# Access Compliance Report

## Public Rights-of-Way

Intersection ID: 44309	Main Street: LINDA_VISTA_LN	Cross Street: OLIVIA_DIANE_LN	Location: NE
ADA ID: 8604476E60F5	Ramp Type: PerpDiag	Initial Pass/Fail: Fail	Overall Compliance: No
Severity Score: 12.5			
Codes/Mitigation Info/Possible Solution		Field Measurements/Component Compliance

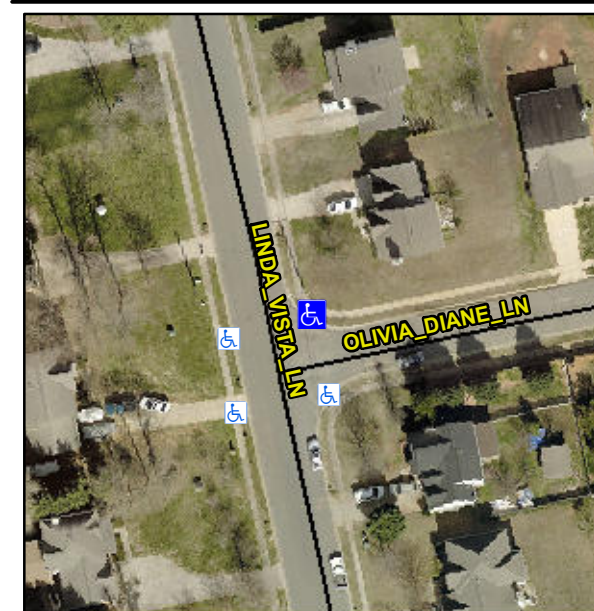
**Remove & Replace Curb Ramp With Two New Directional Ramps or Equivalent.**

**Not Found, R304.5.3**
